**PLANNING APPROVAL,
PLANNED UNIT DEVELOPMENT &
SUBDIVISION STAFF REPORT****Date: June 17, 2010**

<u>NAME</u>	New Shiloh Missionary Baptist Church
<u>SUBDIVISION NAME</u>	New Shiloh Missionary Baptist Church Subdivision, Plat #1
<u>LOCATION</u>	2756 Old Shell Road (Northwest corner of Old Shell Road and Bay Shore Avenue)
<u>CITY COUNCIL DISTRICT</u>	District 1
<u>PRESENT ZONING</u>	R-1, Single-Family Residential District
<u>AREA OF PROPERTY</u>	1 lot / 3.4± acres
<u>CONTEMPLATED USE</u>	Planning Approval to allow the expansion of an existing church in an R-1, Single-Family Residential district, Planned Unit Development approval to allow multiple buildings on a single building site, and Subdivision approval to create one legal lot of record.
<u>TIME SCHEDULE FOR DEVELOPMENT</u>	Immediate.
<u>ENGINEERING COMMENTS</u>	Development of this site shall provide adequate drainage for the runoff that currently discharges across this property from adjacent properties and must not restrict the flow of runoff or cause ponding. Must comply with all storm water and flood control ordinances. The construction of any new dumpster pads will require connection to sanitary sewer, cannot discharge to s

SUBDIVISION DETAIL

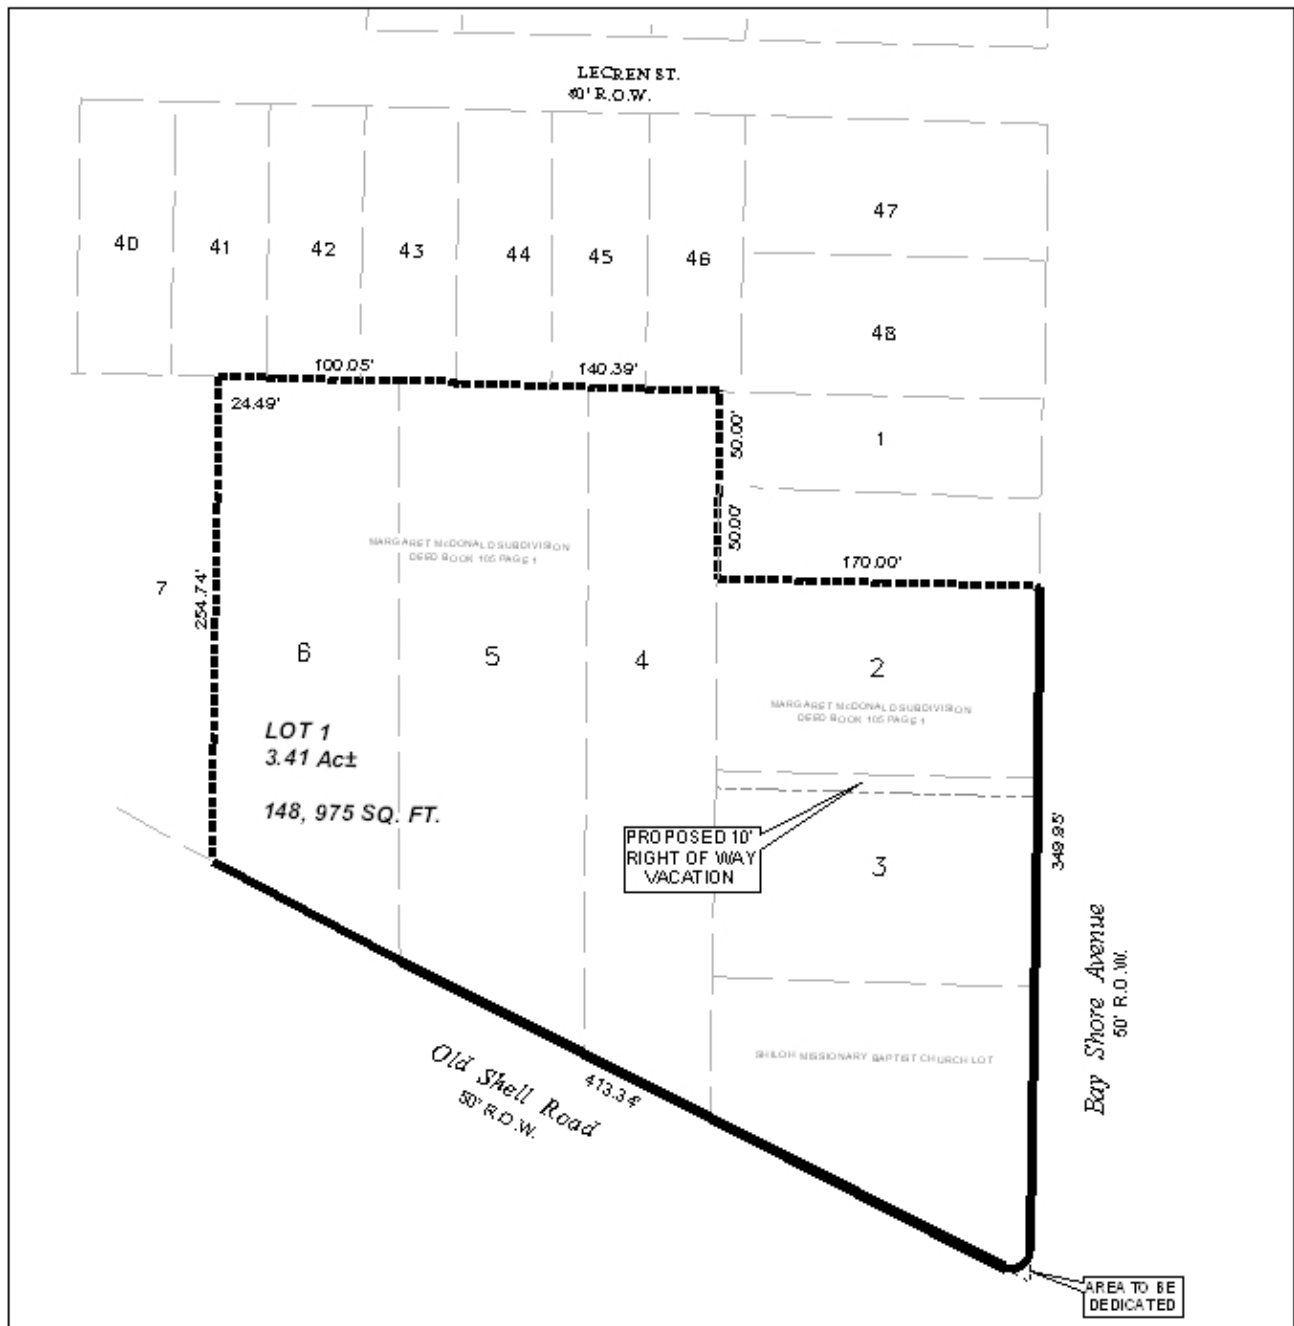
The proposed lot, as depicted, meets the minimum size and frontage requirements as regulated by the Subdivision Regulations. The lot area size is depicted, in square feet, on the plat, and this information should be retained on the final plat, if approved.

Part of the area proposed to be included in the lot appears to be city right-of-way. A 10-foot wide, 170-foot long strip of land was dedicated to the City of Mobile as a "10-foot lane" as depicted on the plat of Margaret McDonald's Subdivision of 1903. No evidence can be found that this Lane was ever vacated by the city, and still shows up on tax records as right-of-way. Additionally, a survey date June 14, 2007, by Byrd Surveying, Inc. (which is on file in a previous, expired Subdivision application) still indicates the 10-foot lane. As such, vacation of the 10-foot lane through the Mobile City Council must be accomplished prior to any permits being issued or signing of the plat.

As stated previously, the site fronts Old Shell Road to the South and Bay Shore Avenue to the East, and both streets are minor streets, provided with curb and gutter. Both streets are depicted with adequate rights-of-way to meet the requirements of Section V.B.14. of the Subdivision Regulations regarding right-of-way widths. Dedication will be required, however, in order for the site to meet the requirements of Section V.D.6. of the Subdivision Regulations regarding curb radii for corner lots.

The 25-foot minimum building line, as required by Section V.D.9. of the Subdivision Regulations is not depicted on the plat, and should be shown along all public right-of-way frontages, including any dedications, on the Final Plat, if approved. It should be noted that the existing structure will not meet the 25-foot minimum building setback, and, as such, it would be considered legal, non-conforming.

Regarding the Subdivision application, the preliminary plat indicates that the corner radii will be dedicated, but does not label the dedication as such. The plat should be revised to label the right-of-way dedication.

Subdivision: *The request is recommended for tentative approval subject to the following conditions:*

- 1) *completion of the vacation process for the 10-foot lane right-of-way prior to signing of the final plat or any permits being issued;*
- 2) *labeling of the dedication sufficient for the lot to comply with Section V.D.6. of the Subdivision Regulations regarding curb radii;*

- 3) *retention of the 25-foot minimum building line along all rights-of-way including any dedications;*
- 4) *retention of the labeling of the lot area size in square feet on the Final Plat;*

- 6) *retention of a note on the Final Plat stating that the lot is limited to one curb cut to Old Shell Road and three curb cuts to Bay Shore Avenue, with the size, location, and design of all curb cuts to be approved by Traffic Engineering and conform to AASHTO standards; and*

SITE PLAN

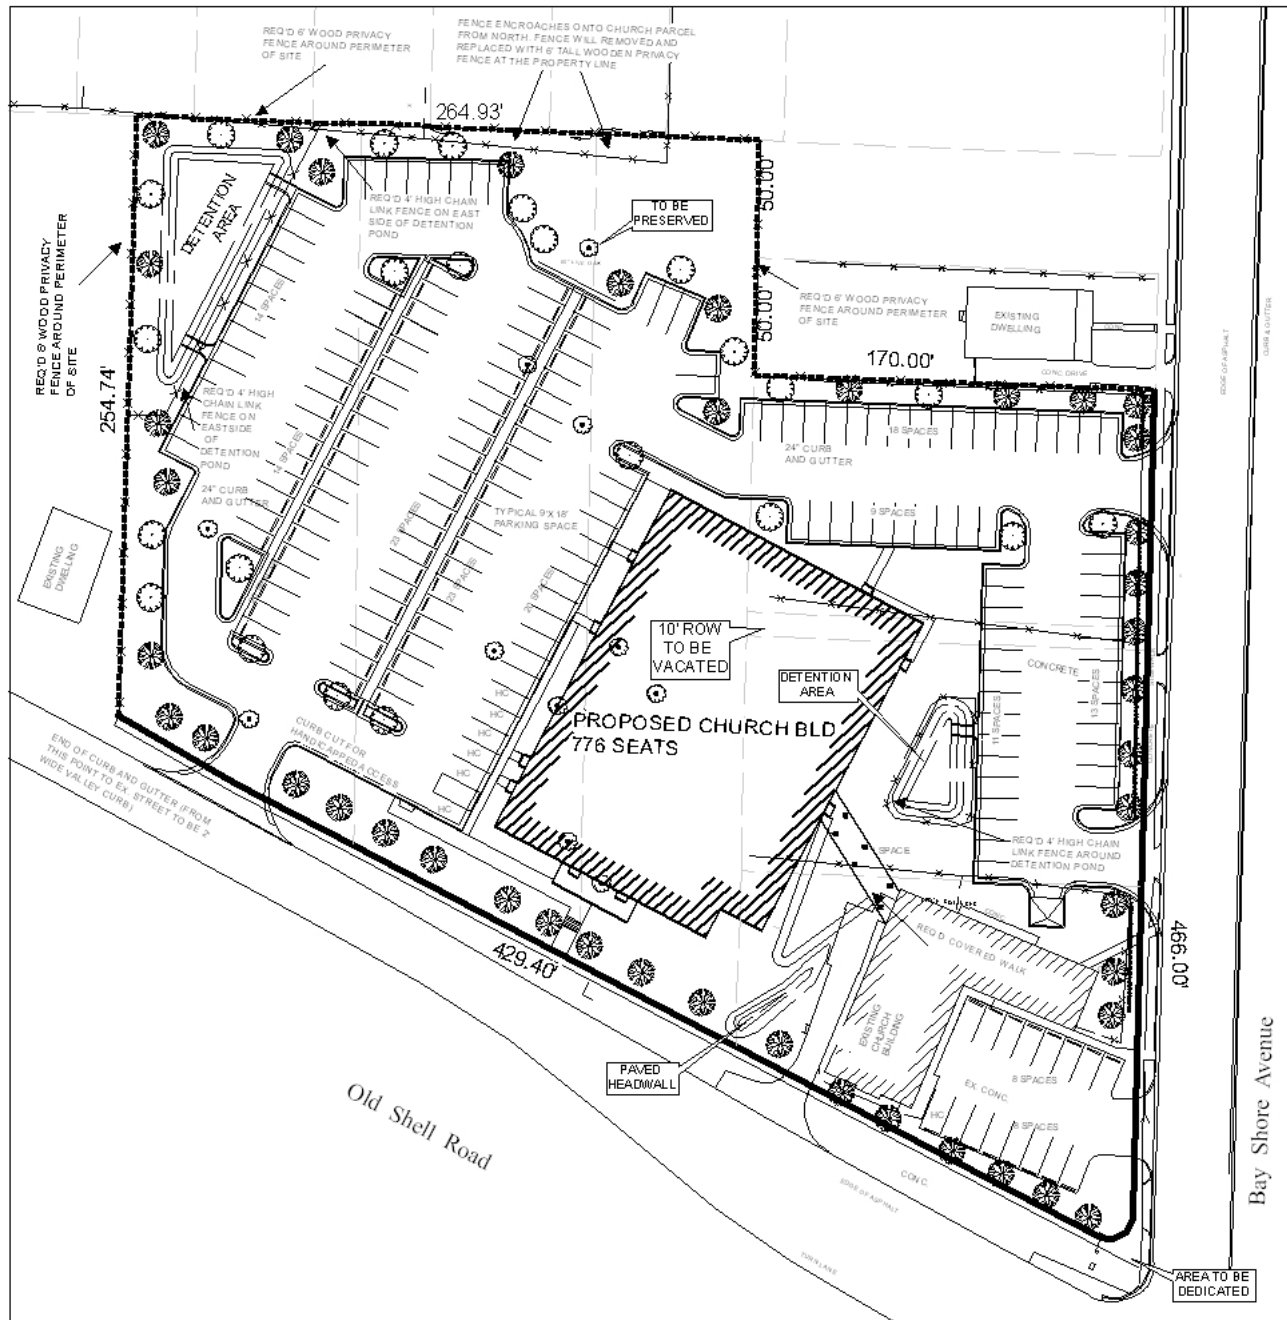
The proposed site plan depicts a number of improvements to the site to bring it into compliance, including new asphalt parking, with spaces and accessways of adequate width and size. There are a few issues that should be addressed, however.

An existing, approximately 10-foot wide concrete driveway off of Old Shell Road is depicted to remain and connect to one of the new parking areas, and serve as a one-way exit to Old Shell Road. This exit to Old Shell Road is not only substandard in width, but it is also unnecessary. As stated earlier, Old Shell Road serves as a collector street. One direct accessway to Old Shell Road is sufficient, as traffic can access Bay Shore Avenue from the other two curb cuts, and then access Old Shell Road at the signalized intersection. As such, this existing curb-cut and one-way accessway should be deleted.

The curb cut to Bay Shore Avenue is currently substandard, and should be brought to City of Mobile standards, including width of 24 feet. Additionally, the existing curb cut is located in an area of the site that should be dedicated in order for the site to comply with Section V.D.6. of the Subdivision Regulations regarding curb radii. As such, the curb cut should be relocated further to the North, and also be modified to meet City of Mobile standards for two-traffic. The alignment of the curb cut should correspond with the 24-foot wide accessway for the parking spaces. Lastly, there is no indication that curbs will be installed at this parking lot, as such, curbs or bumper stops will be required for all parking spaces.

The site plan depicts a 6-foot high wooden privacy fence buffer between the site and the residentially zoned property to the West and North. This fence should be maintained, however, a notation should be made on the site plan that the fence will be no higher than 3 feet in height within the 25-foot front setback.

Because the proposed parking area will provide space for more than 10 cars, the parking lot will have to comply with Section 64-6.A.3.i. of the Zoning Ordinance regarding parking lot screening. The Ordinance requires a 3-foot high brick wall or evergreen hedge to screen the parking lot from view of residential properties across the street. Because the site directly across Old Shell Road is developed commercially as a school, the screening requirements can be waived along Old Shell Road. Similarly, the old Blue Bird Hardware store site is zoned commercially as B-2; as such, screening would not be required here. North of the old Blue Bird Hardware site, along Bay Shore Avenue, screening will be required. Additionally, the site will need to comply with Sections 64-4.A.2. and 64-6.A.3.c. of the Zoning Ordinance regarding illumination of uses and arrangement of lights so as not to shine directly into traffic or residential properties.

No dumpster or information regarding trash service is indicated on the site plan. The site plan should be revised to depict the location of the dumpster pad with proper dumpster enclosure and

Lastly regarding the site plan, the existing church sign is depicted as being within the right-of-way. The sign must be moved to a conforming location on the site with proper permits.

The applicant has submitted revised plans for these applications. The applicant has revised the plan to correct the deficiencies from the previous submittal. Urban Forestry has indicated that the changes to the site plan to protect the 60" live oak tree are adequate and acceptable. Urban Forestry has also indicated that the proposed tree plantings under the canopy area of the proposed tree are not acceptable, and should be redesigned to move the plantings from under the canopy.

A note placed on the site plan regarding lighting appears to have a minor typing error, instead of referencing Section 64-4.A.2. of the Zoning Ordinance, the note references "Section 64-74.A.2." This should be corrected on the revised site plan.

Planning Approval: *The request is recommended for tentative approval subject to the following conditions:*

- 1) *revision of the note regarding site lighting to reference Section 64-4.A.2. of the Zoning ordinance instead of "Section 64-74.A.2.";*
- 2) *full compliance with landscaping and tree planting requirements;*

- 3) *completion of the vacation process for the 10-foot lane right-of-way prior to any permits being issued;*
- 4) *completion of the Subdivision process;*

- 5) *obtaining a sign permit for the relocation of the existing sign on the right-of-way;*
- 6) *full compliance with engineering comments: "Development of this site shall provide adequate drainage for the runoff that currently discharges across this property from adjacent properties and must not restrict the flow of runoff or cause ponding. Must comply with all storm water and flood control ordinances. The construction of any new dumpster pads will require connection to sanitary sewer, cannot discharge to storm sewer. Any work performed in the right of way will require a right of way permit;"*

- 7) *provision of two copies of the revised site plan to the Planning Section of the Urban Development Department prior to the issuance of any permits; and*
- 8) *full compliance with all municipal codes and ordinances.*
